# **ENERGY NORTHWEST**

November 18, 1999  
GO2-99-202

Subject: **WNP-2, OPERATING LICENSE NPF-21  
REQUEST FOR AMENDMENT  
TECHNICAL SPECIFICATION 4.3.1.2.b  
FUEL STORAGE**

**REQUEST FOR AMENDMENT  
TECHNICAL SPECIFICATION 4.3.1.2.b  
FUEL STORAGE**

NEW FUEL STORAGE VAULT FUEL LOADING PATTERN

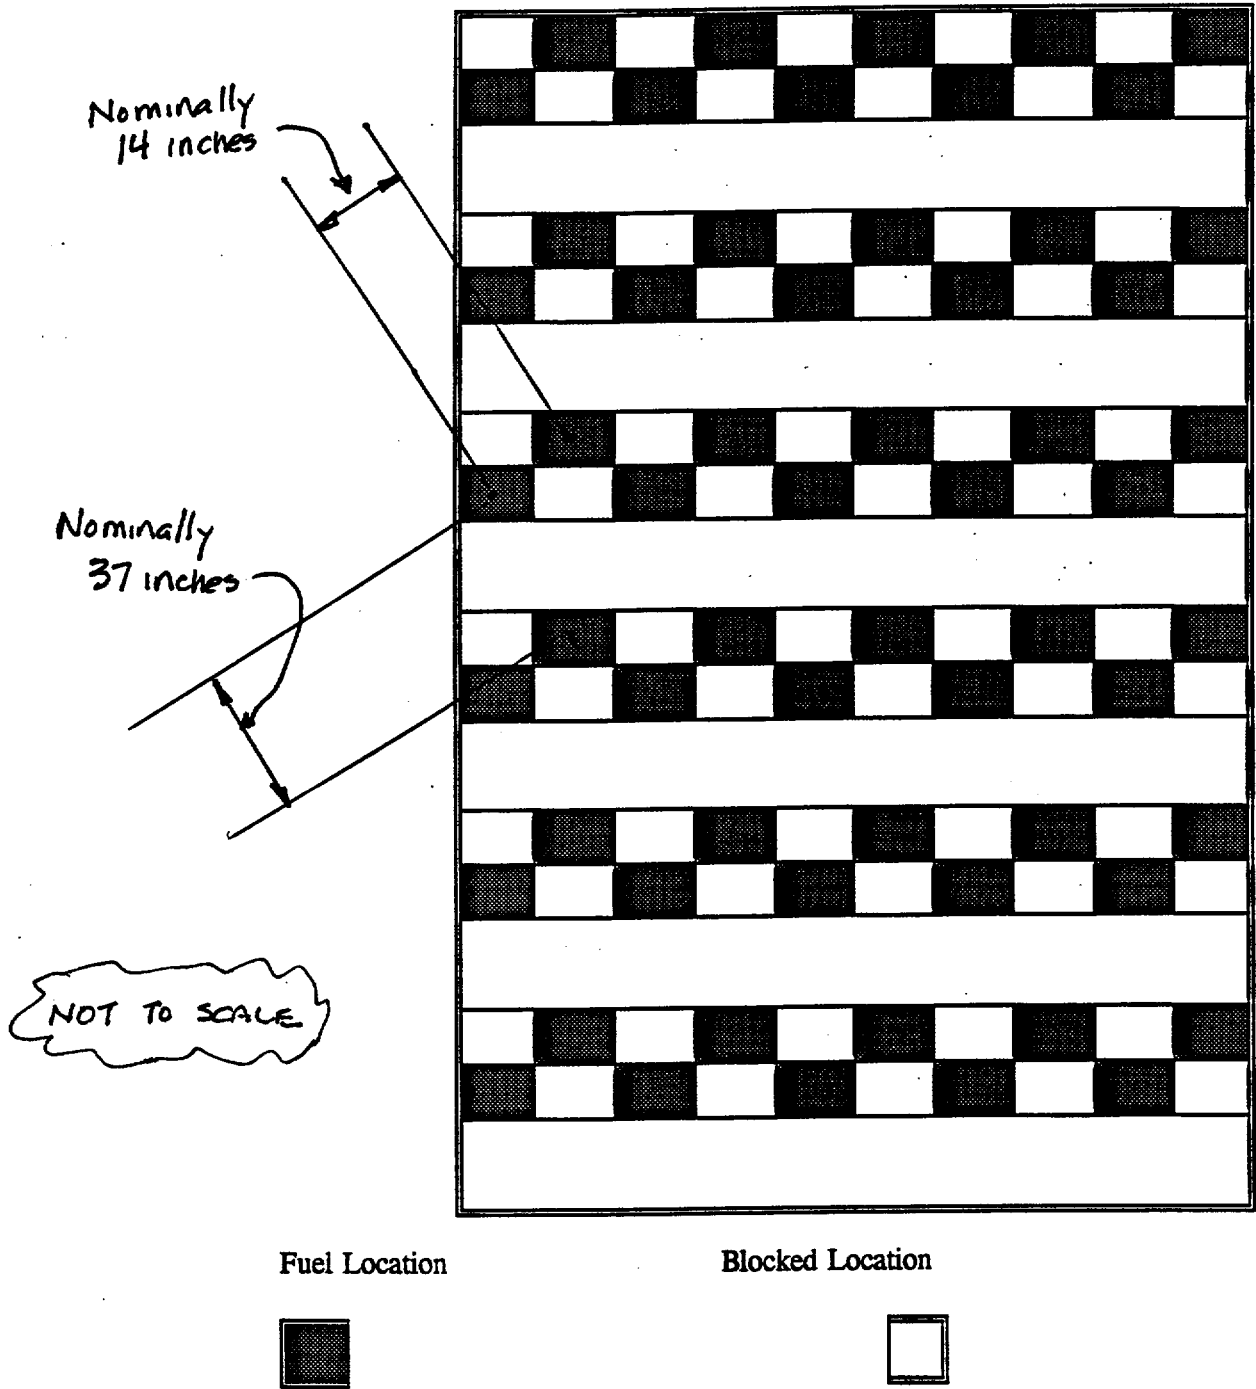
The cell utilization pattern for the fuel consists of 2 contiguous rows in which fuel assemblies may be stored, alternating with 2 contiguous rows in which fuel storage is prohibited. Within a 2-row set in which fuel is stored, alternate cells are physically blocked, in a checkerboard pattern, to prevent inadvertent cell usage. This results in a nominal center-to-center distance between cells for storing fuel assemblies of 14 inches. The nominal center-to-center distance between cells used to store fuel, across the 2-row set in which fuel storage is prohibited, is 37 inches. A sketch of this utilization pattern is included on Page 3 of this attachment.

The above configuration was analyzed to determine the effective neutron multiplication factor,  $k_{eff}$ , for (1) geometrical variations resulting from tolerances for the installation, (2) air as the vault atmosphere, and (3) water as the vault atmosphere in a range of densities varying from 1 to 0.02 gm./cc.

Additionally, postulated accidents were included in the analysis: assemblies dropped on the vault floor, and insertion patterns that varied from the baseline configuration described above. No credit was taken for the neutron absorptive effect of metals comprising the storage rack, the gadolinium and the zirconium cladding in the fuel assemblies, and any metal in the concrete structure of the vault. The analysis was performed using the computer code KENO, with neutron cross-sections calculated using the PHOENIX code. The NRC has approved both codes. The conclusion of the analysis of this configuration is that  $k_{\text{eff}}$  ranges between 0.64 and 0.86 for normal geometry and is 0.898 for a worst-case accident involving an insertion pattern that varied from the specified baseline configuration. The dropped fuel bundle accident resulted in a range of  $k_{\text{eff}}$  of 0.87 to 0.88. Technical Specification 4.3.1.2.a specifies a limiting value of 0.95 for  $k_{\text{eff}}$  when fully flooded with unborated water. In short, the KENO analysis shows a considerable margin of safety for the configuration described above, graphically presented on Page 3 of this attachment, and for configurations resulting from accidents involving dropped fuel assemblies and insertion errors.

- 4.3.1.2 The new fuel storage racks are designed and, with fuel assemblies inserted, shall be maintained with:
- a. (no change)
  - b. A maximum of 60 new fuel assemblies stored in the new fuel storage racks, arranged in 6 spatially separated zones. Within a storage zone, the nominal center-to-center distance between cells for storing fuel assemblies is 14 inches. The nominal center-to-center distance between cells for storing fuel assemblies in adjacent zones is 37 inches. Design features relied upon to spatially limit the placement of fuel bundles within the new fuel vault are required to be installed prior to placement of new fuel bundles in the vault.
